Cambridge Housing Authority
MODERNIZATION OF 116 NORFOLK STREET
2ND SUBMISSION: VOLUME 2 GRAPHICS

Affordable Housing Overlay Submission
August 26, 2022

2.1 AHO Matrix Comments

NORTH YARD TERRACE

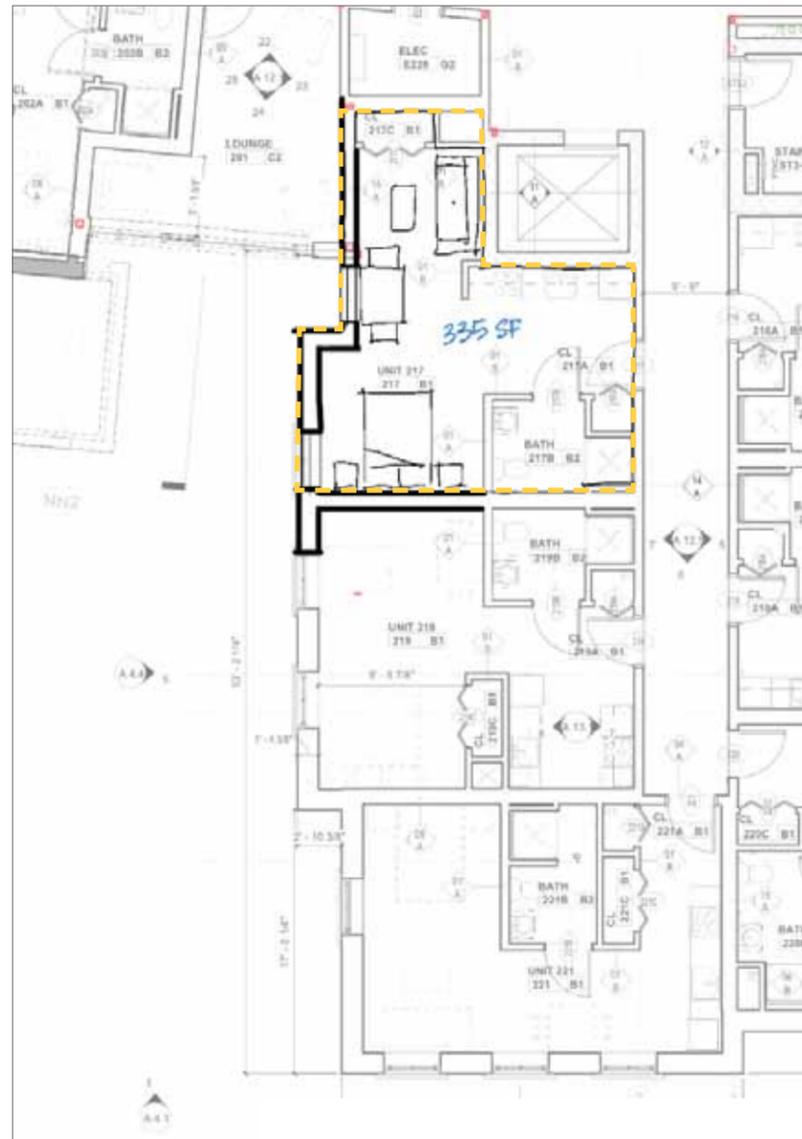
Site Design			
17	X	The deteriorated existing wooden fence atop the south brick wall is proposed to be removed. To make the benches in the south lawn that back onto the south wall (which is approximately four feet tall in that location) more inviting to use, consideration could be given to replacing the wooden fence with a lattice that vines could grow on.	CDD Residents and neighbors expressed interest in a visual connection to the 116 Norfolk entrance from the street, so we are not introducing a lattice for vines. Instead, we are proposing a metal picket fence to site atop the masonry wall to allow more light and visibility. This will allow the entrance to be visible from Suffolk.
18		To enhance the north lawn's presence as a useful open space for residents, consideration could be given to creating steps down from the terrace to the site's north yard. The perimeter wall and gate may be sufficient to obviate potential security concerns about creating a second door to the lobby.	CDD We considered this, however, decided against it. Having stairs up onto the terrace but no ramp would create a completely different path from yard to terrace for people with mobility aides, which would not be equitable or accessible. Furthermore, we do not want to create another entry/exit on the terrace for security reasons. We want the terrace to be used, but there are units right next to the terrace, so we do not want it to be an entry/exit point. We are, however, adding plantings in front of the terrace railing to help soften the transition between yard and the terrace.

- Expanded glazing in the Connector so that it reads as bands of metal panels alternating with bands of glass at each floor.
- Horizontality of the Connector helps link the existing and new buildings.
- Reduced scale of curtain wall assembly so that it no longer reads as a continuous massing from bottom to top.
- Plantings in front of terrace railing help soften the transition between the yard and the terrace.

4-WINDOW PROJECTION & CONNECTOR

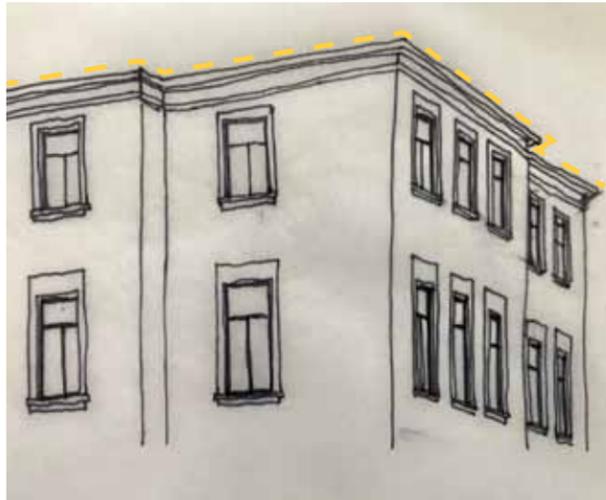
5	X	To reduce the sense of crowding created by the second and third floor projecting element on the west side of the addition, consideration could be given to raising the soffit on its underside to correspond with that of the existing south porch.	CDD We have raised the soffit so that the underside of the soffit aligns with the underside of the porch.
6	X	Consideration could be given to providing a larger canopy above the entry door, and to aligning it with the roof of the existing south porch.	CDD We are expanding the canopy at the entrance to 6' wide by 4' deep and adding the address ("116 Norfolk") in a bright blue above the canopy to draw further attention to the entrance. We explored aligning the canopy with the roof of the existing south porch, however, we felt that crowded the entrance and was too high above the door to protect from rain and serve as a practical canopy.
7		Consideration could be given to reducing the intrusion of the addition's second floor into the entry area. Another suggestion for the entry area was to pull back a portion of units 217 and 317 to create a three-window projection that provides additional visual space	PB We considered this, however, shrinking the projection to three windows, removes 35 square feet from units 217 and 317, reducing them from 370 SF to 335 SF, and making them difficult to furnish. In addition, this would also make units 217 and 317 darker because the second window in the unit (closest to the connector) would be cast in shadow by the bay.

8	X	The [main entrance] door seems small, more of a side door to the building than the main entrance.	CDD We have enlarged the front door and canopy at the main entrance.
9		Consideration could be given to adding a porch on the new entry that relates to the design of the existing porch, thereby signaling the location of the new building entry	PB There is not enough space for a new porch along the addition or at the entrance. We feel a new porch would cramp the entrance by blocking the view to the entrance from Suffolk Street. We also cannot raise the height of the entry given the challenges of connecting the floors of the two buildings while meeting the provision in the AHO that doesn't allow the first floor to be over four feet from the ground (Section 11.207.7.4). Without raising the entry height, we cannot add a porch directly next to the entry without crowding it.
10	X	Consideration could be given to using taller windows, or to giving the blank panels above them a three-dimensional relief treatment.	CDD The proposed windows are large at 7'-1" tall x 3'-2" wide on the first floor, 6'-7" x 3'-2" on the second floor, 4'-11" x 3'-2" on the third floor. (Like on the existing building, the windows get smaller on the second and third floors.) On the first and second floors we have decreased the size of the frame above the windows to improve window to frame proportions. We have also added a reveal detail on the frame above the windows on the first floor. Per 11.207.7.3, at least 20% of the area of building facades facing a public street or a public open space shall consist of clear glass windows. Public-facing facades on the proposed design have a window-wall ration of 22%. By comparison, the window-wall ratio on the existing building is 18%.

Raised the bottom of the projection/soffit height to align with the top of porch columns to create one sightline and reduce the sense of crowding at the main entrance.

Enlarged door (6' wide) and canopy (6' wide x 4' deep).

Added signage on canopy to emphasize entrance.

Increased glazing on Connector so it reads as bands of metal panels alternating with bands of glass at each floor, and reduces scale of curtain wall assembly.

Maintained horizontality of Connector to link the existing and new buildings.

Updated glass frit design at entrance to allow transparency while providing some privacy for residents picking up letters and packages in the mailroom.

2.5 Landscape Plan

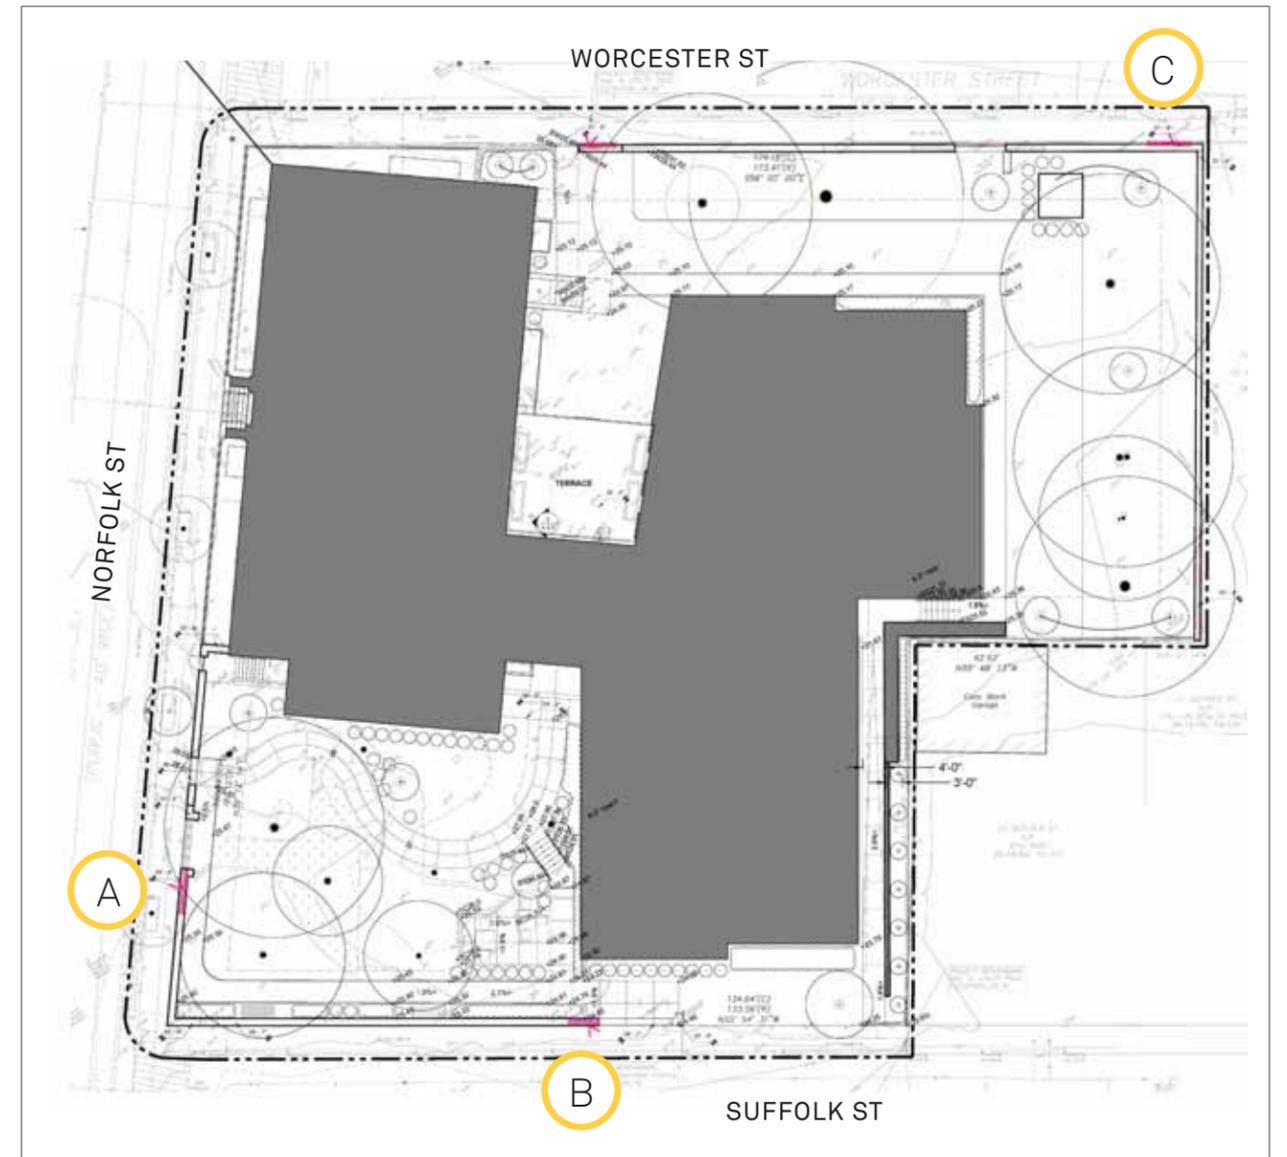
3	X	Consideration could be given to raising the grade of the lawn adjoining the path to blend the path's slope into the general slope of the lawn as the path ascends to first floor level and providing a more direct path to the entry from Suffolk.	CDD We agree that the slope of the path should be blended into the lawn. The landscape plan blends the path's slope into the general slope so that both the grading of the south yard and path lead people directly to the new entrance. This is the most direct path that does not require a ramp with handrails.
4	X	To give the entrance more emphasis, consideration could be given to a more inventive or playful treatment of the lobby's glazed facades: revising the arrangement of mullions, glazed panels, and solid panels to treat the glazed link as a more significant element in its own right.	CDD We agree that it is important to emphasize the entrance and advance the design of the connection. We have extended the glazing to the existing and new building in order to increase the amount of glazing and make the scale more residential. The curtain wall at the connector has been updated to include a band of metal panels at each floor level alternating with bands of glass. This helps reduce the scale of the curtain wall assembly because it no longer looks so continuous from the ground up to the roof. The depth of some of the curtain wall mullions has been adjusted to emphasize the horizontality of these bands. These changes help the connector relate to the adjacent projection. The horizontal lines of the connector relate to the existing, addition, and entrance. The glass frit design at the entrance has also been updated to allow transparency while providing some privacy for residents picking up letters and packages in the mailroom.

PB/CDD COMMENTS & CHA RESPONSES			
Comment #	Done?	Comment	CHA Response
Accessibility			
12	X	Clarification on whether a handrail will be required for the proposed entrance walkway.	PB A handrail will not be required for the proposed entrance walkway due to the gradual slope at less than 1:20 feet.
13	X	Look at path from pick up/drop off space from the street to the site to the entrance. Is it accessible given width of the sidewalks, tree placement, etc?	PB We agree that accessibility is key in designing the entrance route, from the pick-up/drop-off space to the front door. The overall width of the sidewalk is approximately 7'-5", with a 4'-1" width of the sidewalk between the street tree well and the site wall. 521 CMR 22.2 states, "Width of walkways shall not be less than 48", excluding curb stones. An unobstructed path of travel shall be provided which is at least 36" clear, excluding curb stones."Therefore, this area of the sidewalk is accessible and MAAB-compliant.

Norfolk Street main entrance
(widened double-width, no gate)

Pick-up / Drop-off: Route to front entrance via sloped path is fully accessible.

- Overall sidewalk width is approximately 7'-5", with a 4'-1" width of the sidewalk between the street tree well and the site wall. This complies with the minimum 48" width required for accessibility.

Plantings in front of terrace railing help soften the transition between the yard and the terrace.

Slope of path to front entrance is blended into the grading of the south yard landscape.

- Most direct path from the street to front entrance.
- Less than 1:20 slope, no ramp or handrails required.
